ADDENDUM No. 03: September 20, 2024

PROJECT: DELGADO COMMUNITY COLLEGE
DECKHAND TRAINING CENTER
13200 OLD GENTILLY ROAD
NEW ORLEANS, LOUISIANA 70129

PROJECT NO.: STBA PROJECT #41177.01
EDA PROJECT #08-01-05352

FROM: SIZELER THOMPSON BROWN ARCHITECTS
300 Lafayette Street, Suite 200
New Orleans, Louisiana 70130
(504) 523-6472

1
S103
FOUNDATION PLAN
1/8" = 1'-0"

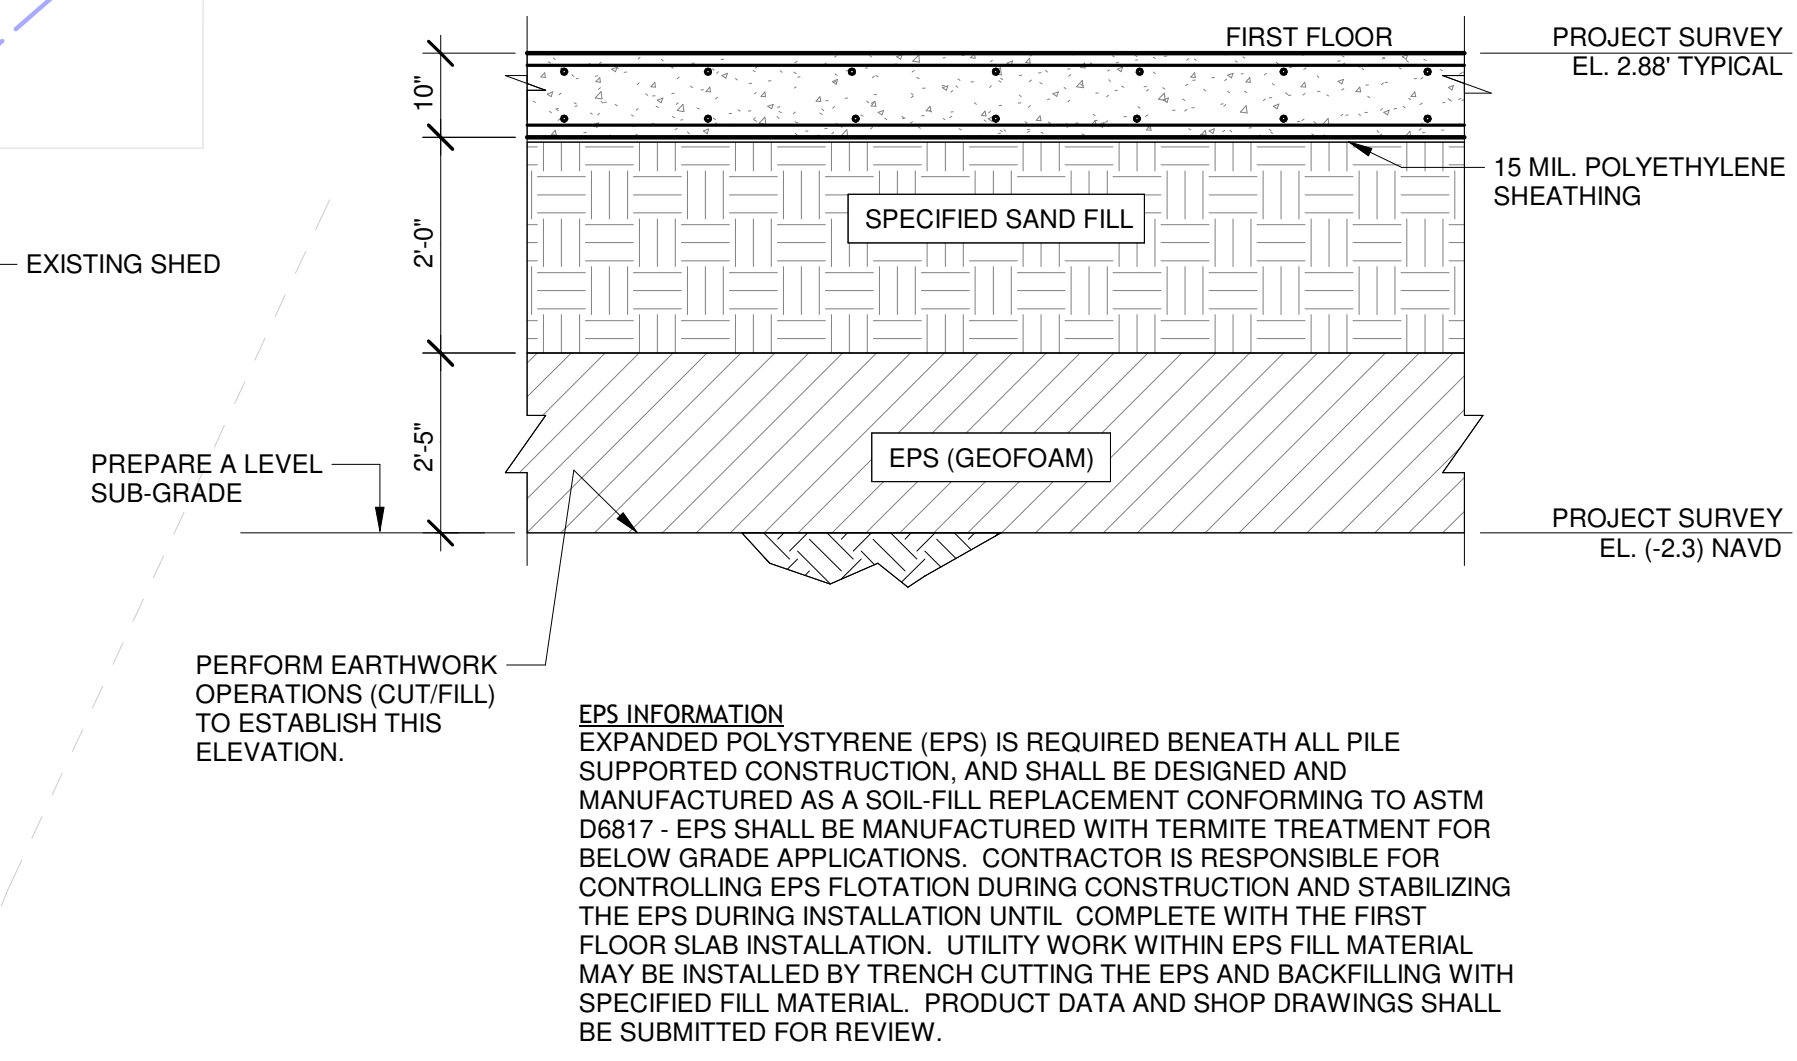
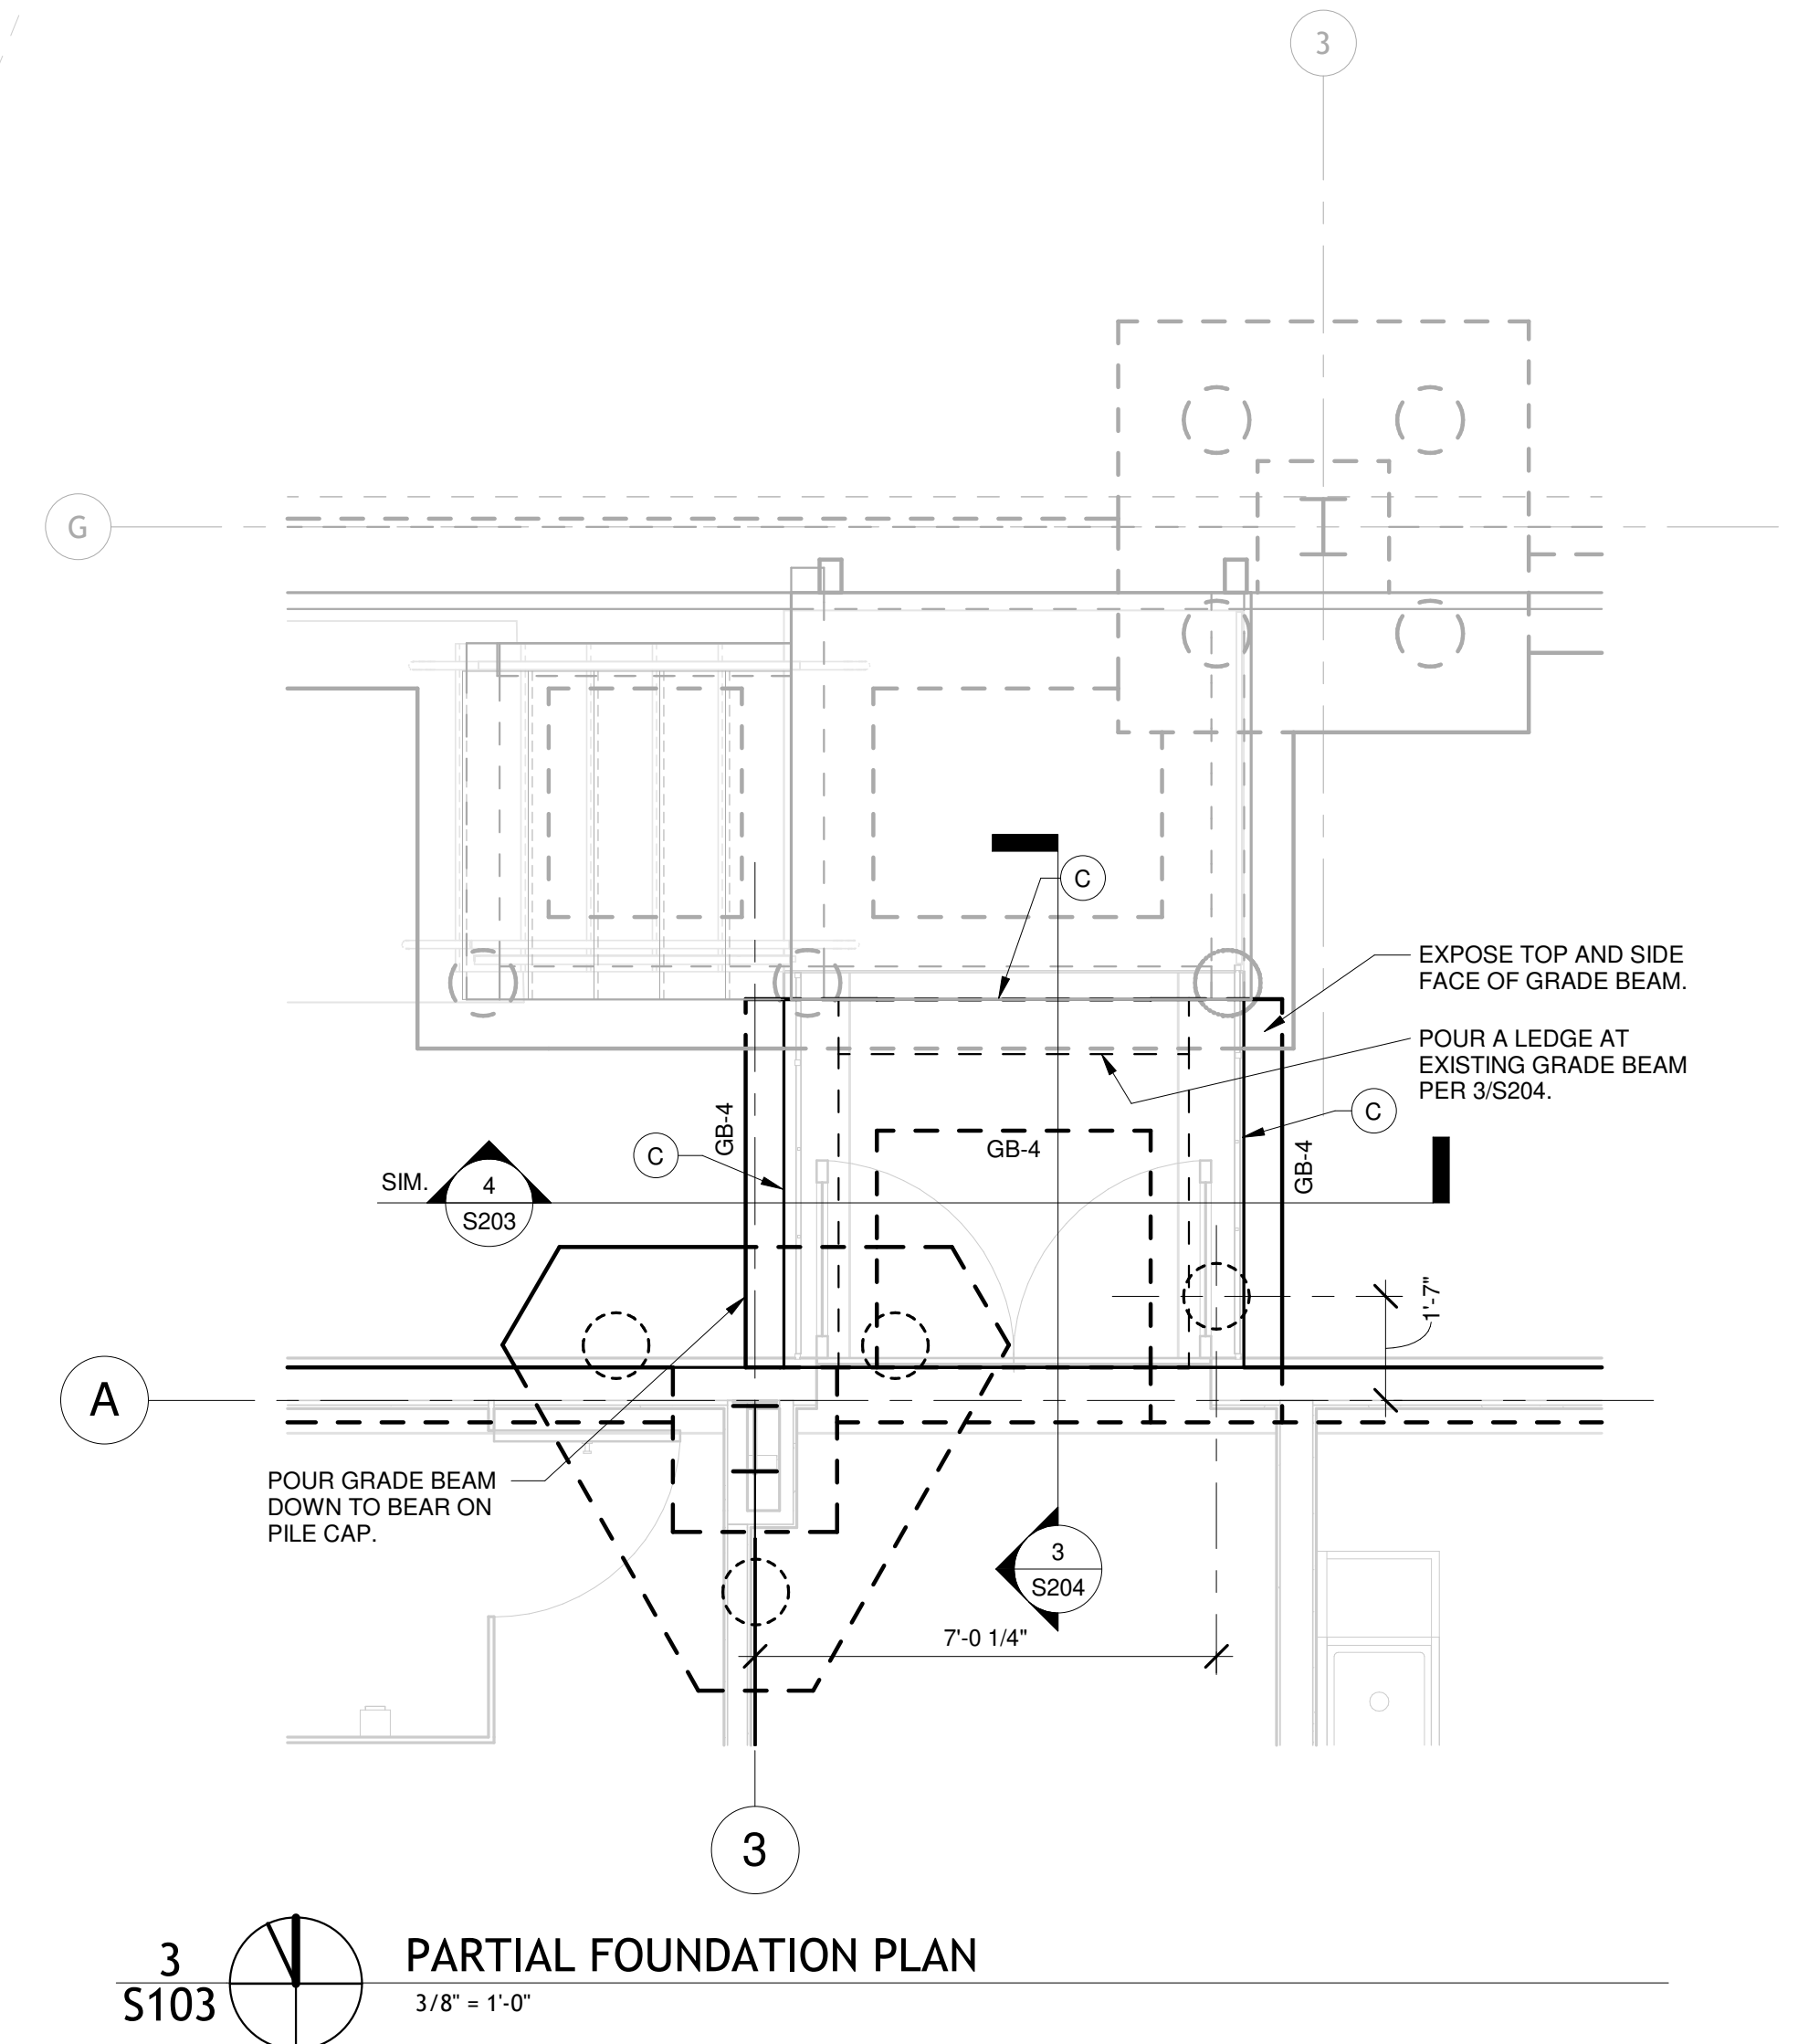
S103 Revision Date 09.20.24
Modifications to equipment pad.
